Dear Commissioners and Staff,

The Southern Renewable Energy Association (SREA) is an industry-led initiative that promotes responsible use and development of wind energy, solar energy, energy storage and transmission solutions in the South. We appreciate the opportunity to provide comments on Entergy Louisiana, LLC'S Final 2019 Integrated Resource Plan (IRP). As contrasted to the collaborative stakeholder processes with Cleco's and Southwestern Electric Power Company's (SWEPCO) IRP's, ELL's IRP is noncompliant with the Louisiana Public Service Commission's (LPSC's) IRP rules, and has been contrary to best planning practices. As such, ELL's IRP poses significant risks to Louisiana ratepayers. SREA recommends that this Final IRP be rejected by the Commission.

### **Disputed Item #1: Capacity-Only Planning is Deficient**

### Entergy System Energy Purchases and Fuel-Only Costs

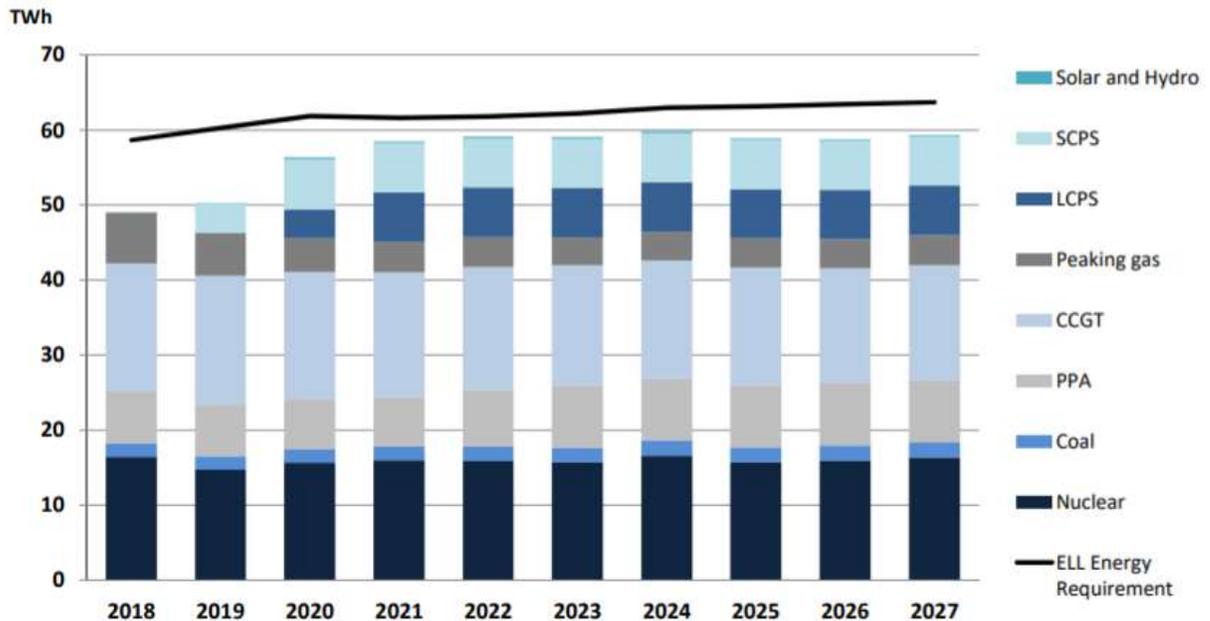
Lower cost energy resources, like wind energy and solar power, will not be selected in ELL's AURORA modeling runs until ELL inputs a capacity need. In effect, ELL is spending more to procure higher cost energy through the MISO market, than what it would if the company were to procure renewable energy resources, and will continue to do so for the next decade. Some 20% of ELL's energy was purchased through MISO in 2018 at a cost of approximately \$37.10/MWh. An additional 9% of ELL's energy was procured potentially at a cost of \$52.30/MWh.<sup>3</sup> ELL projects an energy need in its Final IRP. Because Entergy is the largest provider of energy in the MISO South market, it is entirely possible that ELL customers are procuring energy resources from other Entergy subsidiaries, subsidizing those systems.

ELL's "Heuristic" Solar Capacity Assumptions

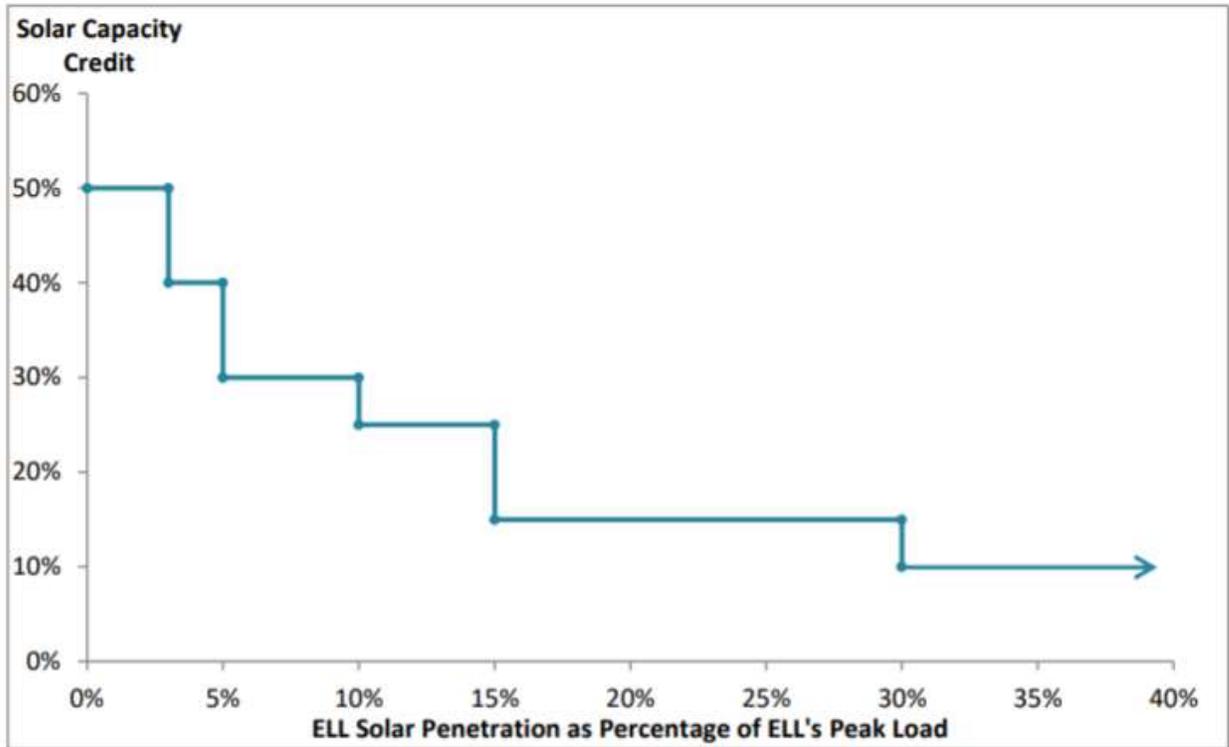
SREA recommended that capacity values for various wind energy and solar energy resources should be provided as a comparison against ELL'S peak load, as well as against MISO's peak load, in addition to MISO's wind energy and solar energy capacity valuations. ELL responded, "ELL's assumed solar capacity credit and wind credit are based on the MISO Tariff. Please see Table 10: Renewable Modeling Assumptions and Section "Solar Capacity Credit Modeling" for more information on assumptions used for solar and wind generation." MISO's capacity accreditation methodology constantly undergoes review and revision. As such, MISO's standard capacity accreditation is a static metric, and other methodologies may arise over time.

Further, ELL misrepresents MISO's work. ELL never cites where its "heuristic" concept is derived, but SREA is familiar with MISO's Renewable Integration Impact Assessment (RIIA) work. Currently MISO's RIIA is a work-in-progress and does not reflect an end-result, a final product, nor an adopted methodology by MISO. Even so, ELL's "heuristic" approach does not actually match MISO's own preliminary results. ELL's "heuristic" approach shows that solar power capacity credit would drop to approximately 10% at 30% penetration level of ELL's system. But MISO's RIIA results show that the effective load carrying capacity (ELCC) of solar power does not drop to 10% until after nearly 70,000 MW's of solar are added to the *entire* MISO system.

### MISO Renewable Integration Impact Assessment Results 2018

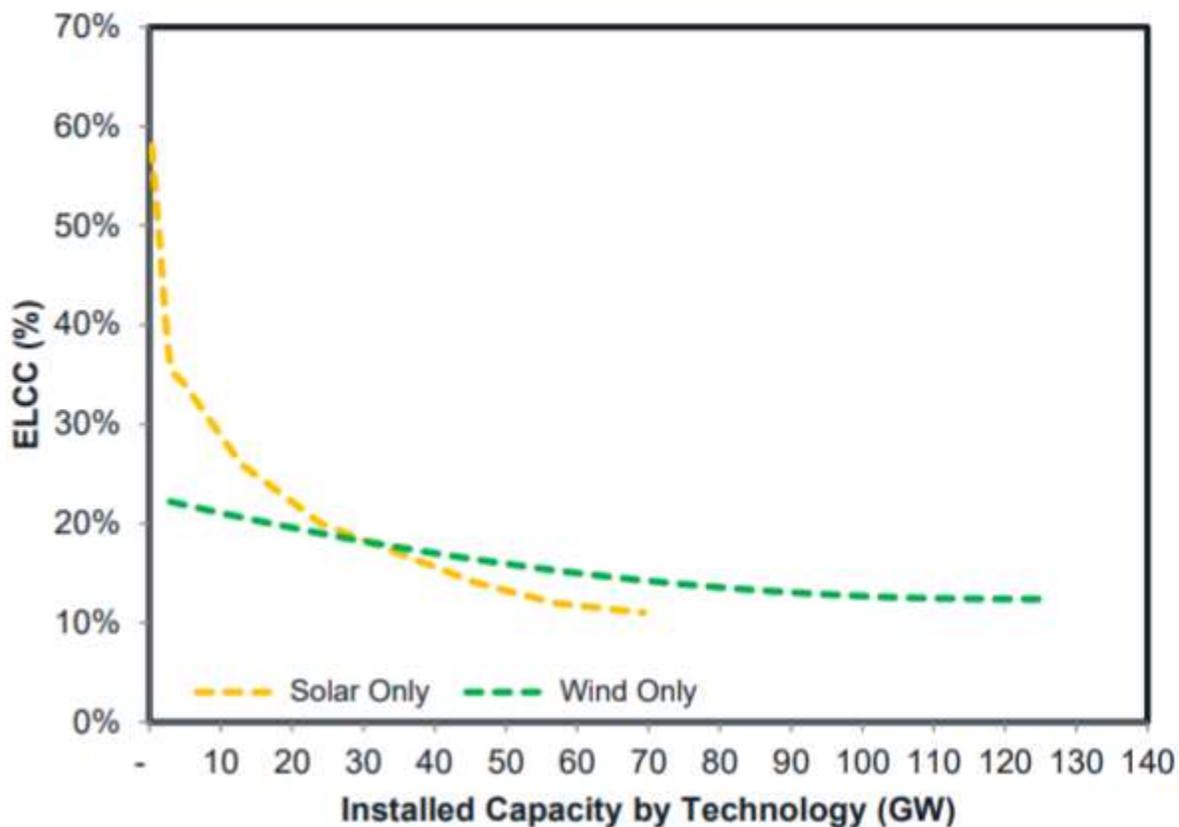
MISO’s RIIA study goes further to identify possible solutions to a degrading ELCC. Some solutions include incorporating both wind energy and solar energy together, adding energy storage resources, geographic diversity and even expanding transmission. ELL’s refusal to evaluate transmission expansion in this IRP artificially constrains the ELCC for solar power, dealing double-damage to renewable energy resources. MISO has stated that “Under RIIA assumptions, most issues up to 20% renewables may be fixed by reconducting only; integration complexity for 20% renewable milestone is in general relatively mild for MISO footprint in steady-state Operating Reliability.”<sup>31</sup> Therefore, ELL’s development of an inaccurate “heuristic” capacity value for renewable energy resources is premature.
